MFN 06-284

Subject: **Response to NRC Request for Additional Information Letter No. 18
Related to ESBWR Design Certification Application - Containment
Design - RAI Numbers 6.2-11, 6.2-21, 6.2-26 and 6.2-27**

**Response to NRC Request for
Additional Information Letter No. 18
Related to ESBWR Design Certification Application
Containment Design
RAI Numbers 6.2-11, 6.2-21, 6.2-26 and 6.2-27**

Figure 6.2-11.1 Drywell Pressure Responses of 4 LOCA Types

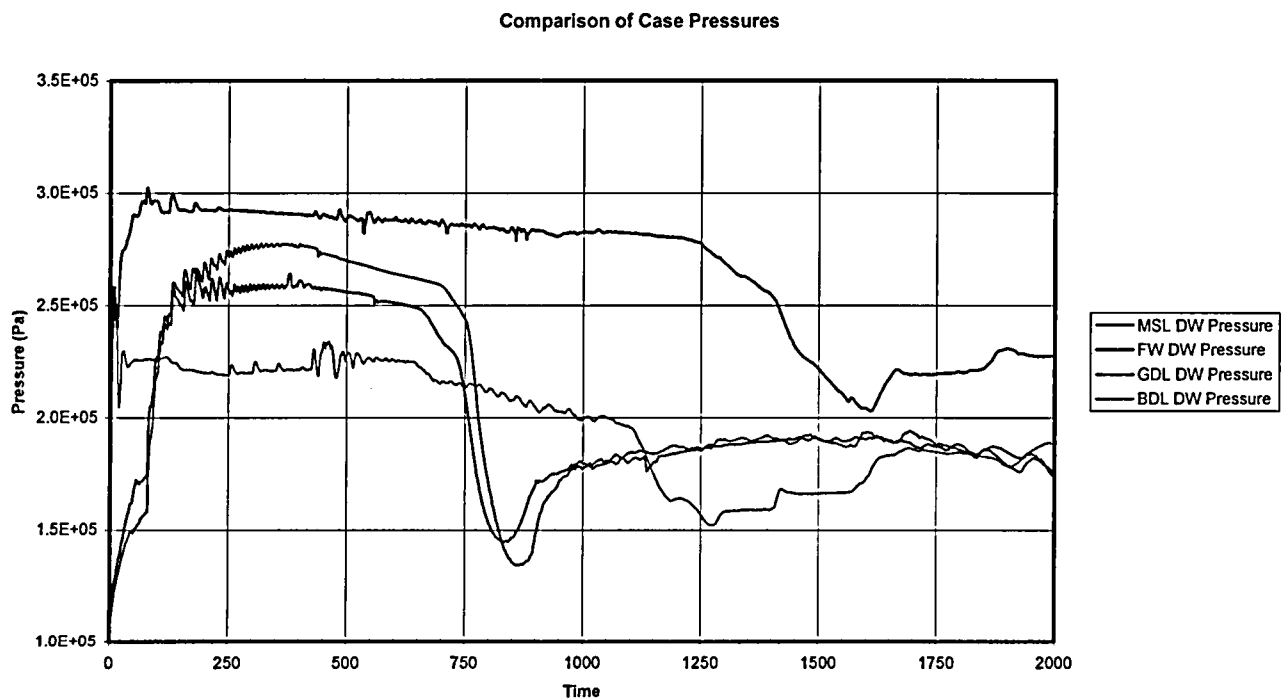
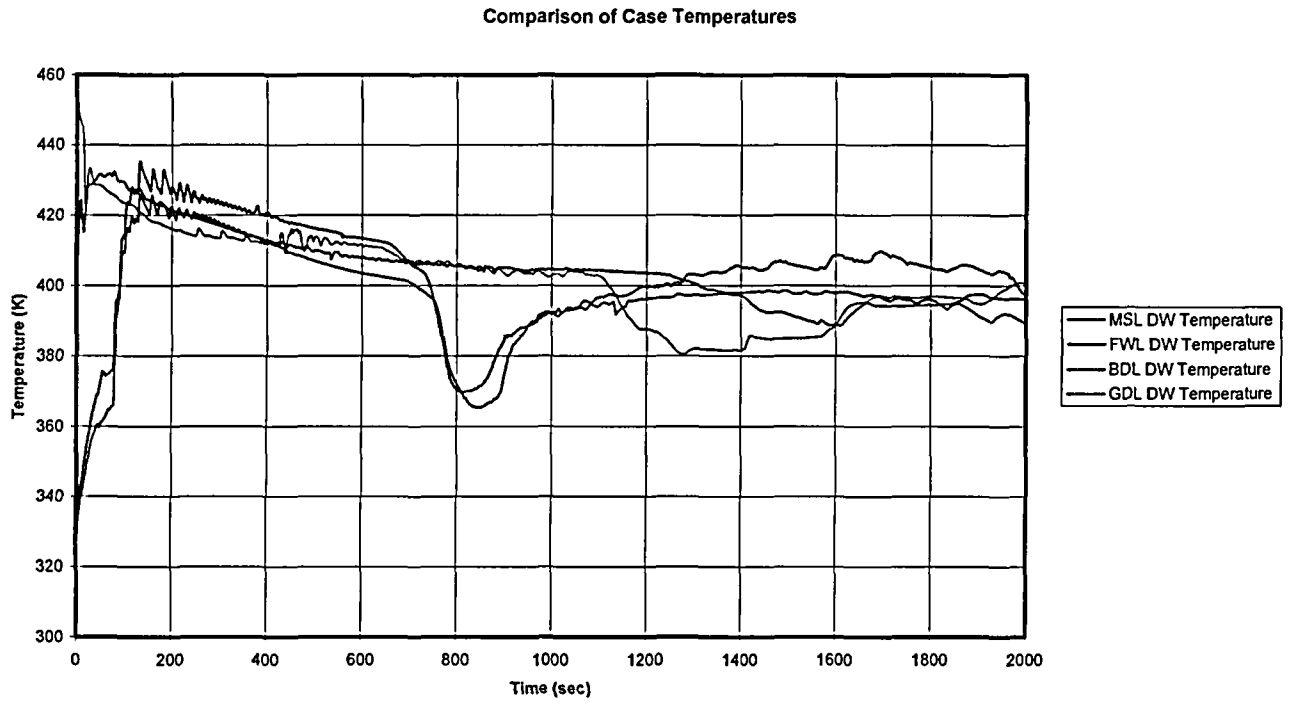
Provide the results of the evaluation(s) and compare to the design value(s). The DCD Section 6.2.1.1.4 indicates that the MSLB will not result in unacceptable results but it does not indicate if other LOCAs were evaluated to conclude this is the limiting case. Provide a discussion on how the limiting cases were identified, for both the drywell and wetwell. Address drywell results and, as appropriate, wetwell results.

Among four design base LOCA break types analyzed for DCD, Feedwater Line (FWL) break results in the highest peak drywell (DW) pressure and Main Steam Line (MSL) break results in the lowest peak DW pressure. The peak pressure of GDCS Injection Line (GDL) or Bottom Drain Line (BDL) break falls between those of FWL and MSL breaks, as shown in Figure 6.2-11.1. DW temperatures are comparable for these 4 types of breaks, except that FWL and MSL cases have higher temperature between 800 and 1100 seconds, as shown in Figure 6.2-11.2. It is therefore adequate to analyze FWL and MSL break scenarios to provide diverse DW environmental conditions which envelope other break locations, for determining the minimum DW pressure and the pressure differential between WW and DW as consequence of inadvertent initiation of drywell spray. The results are tabulated below. An inadvertent drywell spray initiation during a MSLB resulted in a lower DW pressure. An inadvertent drywell spray initiation during a FWLB resulted in a higher WW to DW pressure differentials. The results are all within the design capability. An inadvertent drywell spray initiation during a normal operation was also analyzed and the results were inconsequential.

The second sentence of the last paragraph of DCD Section 6.2.1.1.4 will be revised to read:

“The Feed Water Line (FWL) and Main Steam Line (MSL) break scenarios provide diverse Drywell environmental conditions which envelope the other break locations. The results of the FWL and MSL break analyses show that the containment does not reach a negative pressure relative to the reactor building, and the maximum Wetwell-Drywell differential pressures are within the design capability.”
